FTI-STP1: Vehicle Coverage and Preparation Notes

FTI-STP1: Installation and Configuration Notes

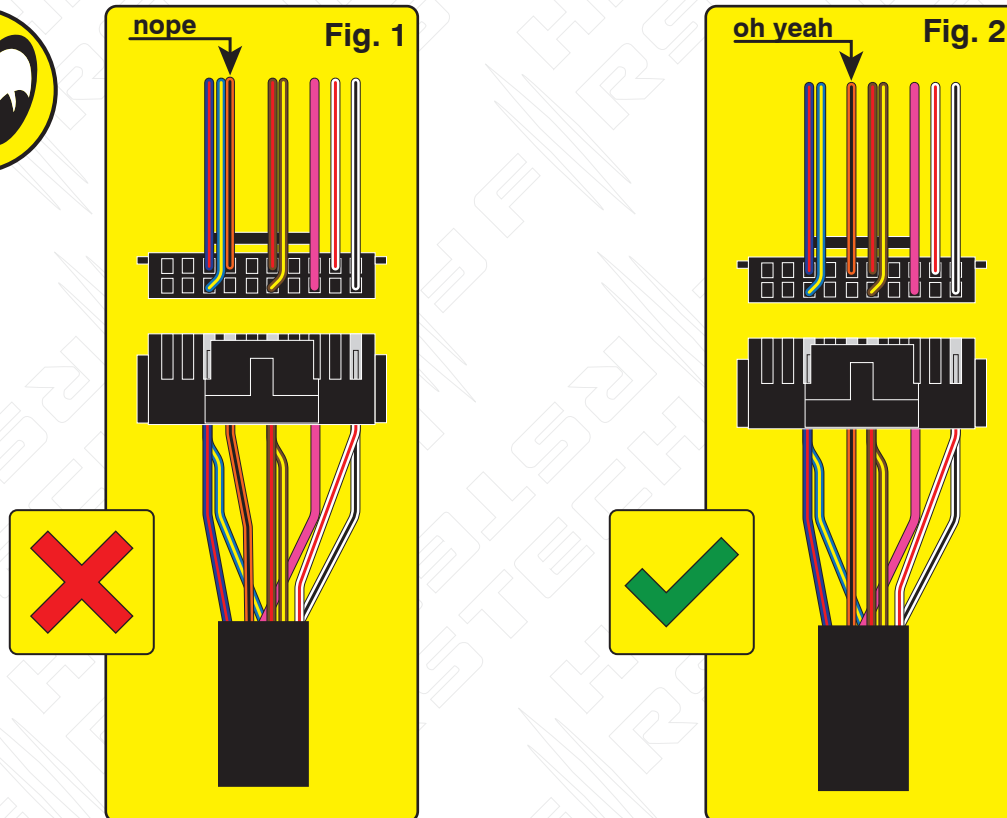
Overview: Production error in version 1.0 harnesses; The immobilizer wire (orange/black) is in pin position #4 instead of pin position #5. Although an effort to correct the issue was made, some quantity of harnesses did get shipped before the issue was spotted. We are advising to inspect the harness BLADE connector before attempting to install harness or program the module. This issue is not known to affect the version 2 harnesses, which require no modification.

Issue: Module fails to program correctly to vehicle, does not allow the vehicle to be remote started.

Correction: Step 1.) Locate the orange/black wire and confirm whether it is positioned as illustrated in Fig. 1 or Fig. 2. If the wire is as illustrated in Fig.1, proceed with Step 2 through 5 and complete the repair procedure outlined, if the wire is as illustrated in Fig. 2, correction is not necessary, proceed with harness installation and module programming.

Step 2.) Using a pick, lightly depress the catch that secures the terminal in the housing then remove the wire and terminal from the housing.

Step 3.) Using a fine tip razor or utility knife, insert the blade beneath the terminal catch and raise it slightly, so that it can be reused to secure the terminal when reinserted into the BLADE connector housing.

Step 4.) Refer to Fig. 2 for correct position of the orange/black wire (next to brown/red) then reinsert the terminal, pressing lightly until the catch 'snaps' into place, securing the terminal in the connector housing.

MODIFICATION REQUIRED FOR A/T APPLICATIONS, ONLY WITH v 1.0 HARNESS

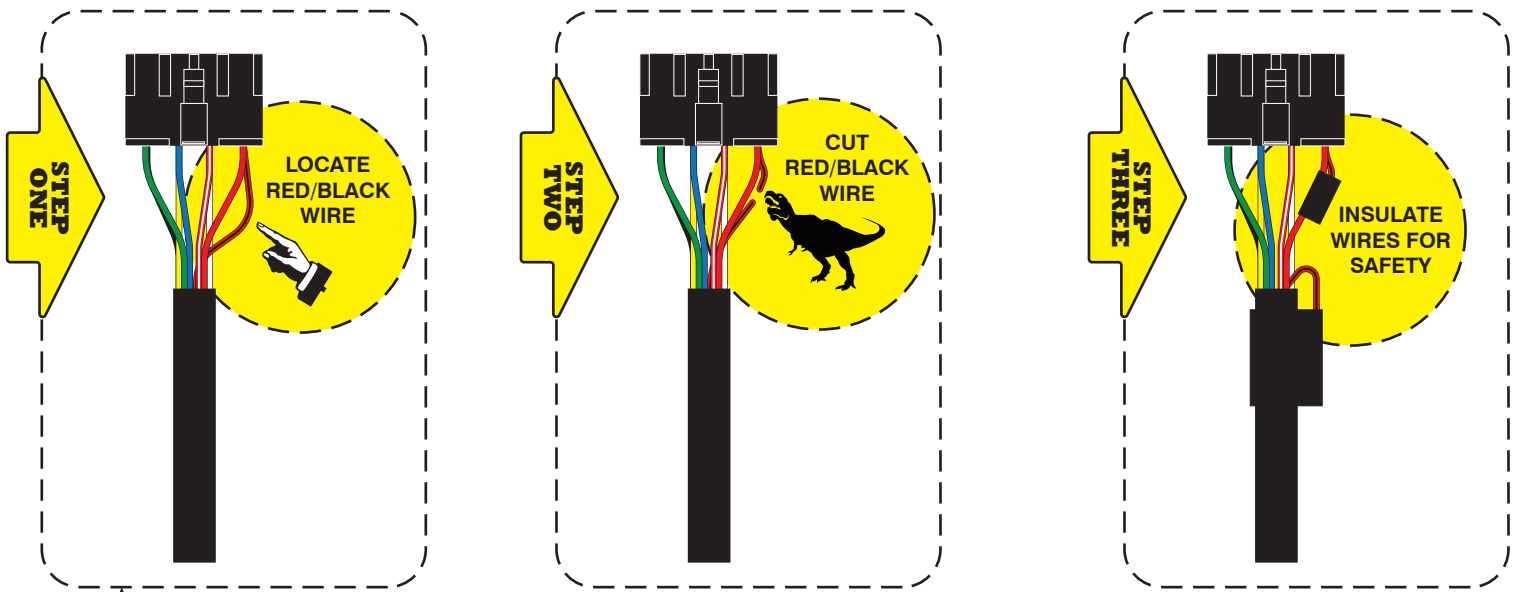
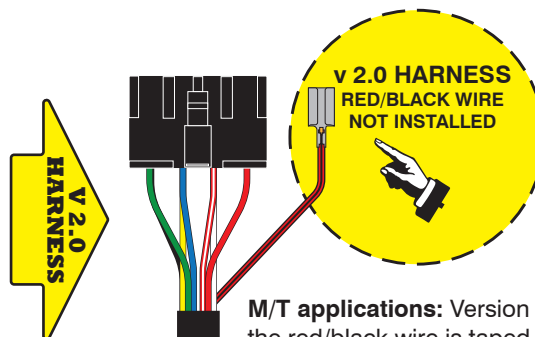
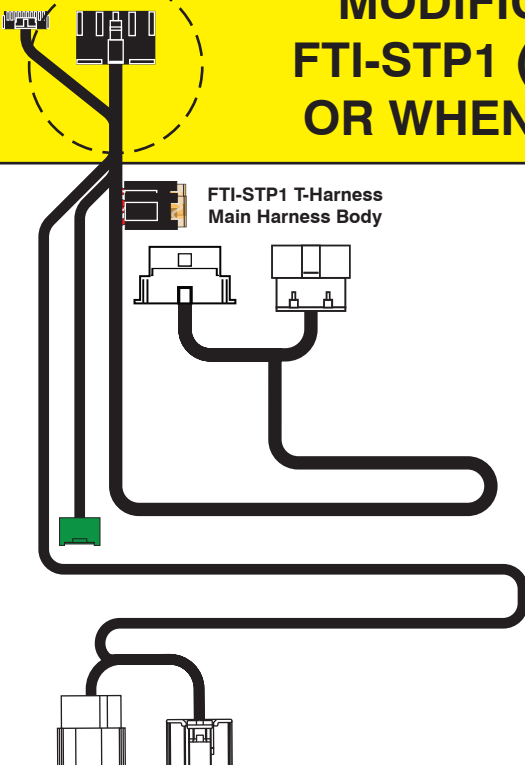
Overview: Early versions of the FTI-STP1 harness require modification for **automatic transmission (AT)** applications, some of the product was able to be modified before release, but a small quantity was released without modification.

Issue: The FTI-STP1 T-harness has been designed to be compatible with A/T (automatic transmission) & M/T (manual transmission) applications, but due to an oversight in early production runs, the selection was defaulted to M/T mode.

Using a harness configured for an M/T application, in an A/T equipped vehicle, could result in vehicle module damage, it is advised that the harness be returned to A/T mode before installation in vehicles equipped with an automatic transmission.

Correction: Locate the **red/black (+ Clutch)** wire provided in the CN1 connector of the main harness assembly. Cut the **red/black** wire, either flush to the CN1 connector, or leaving enough wire exposed so that you can insulate and secure the ends of the wire that remain after cutting. Insulate each of the remaining ends of the **red/black** wire and secure to prevent any possibility of a short circuit. **If the red/black wire has already been disconnected, no further modification is required for A/T applications**

MODIFICATION NOT REQUIRED WHEN USING FTI-STP1 (v 1.0) HARNESS IN M/T APPLICATIONS, OR WHEN USING THE FTI-STP1 (v 2.0) HARNESS

M/T applications: Version 2.0 harness, the red/black wire is taped to the main harness when shipped, and must be installed in the CN1 connector when installed.

A/T applications: Leave the red/black wire taped to the harness, it is not required for A/T applications
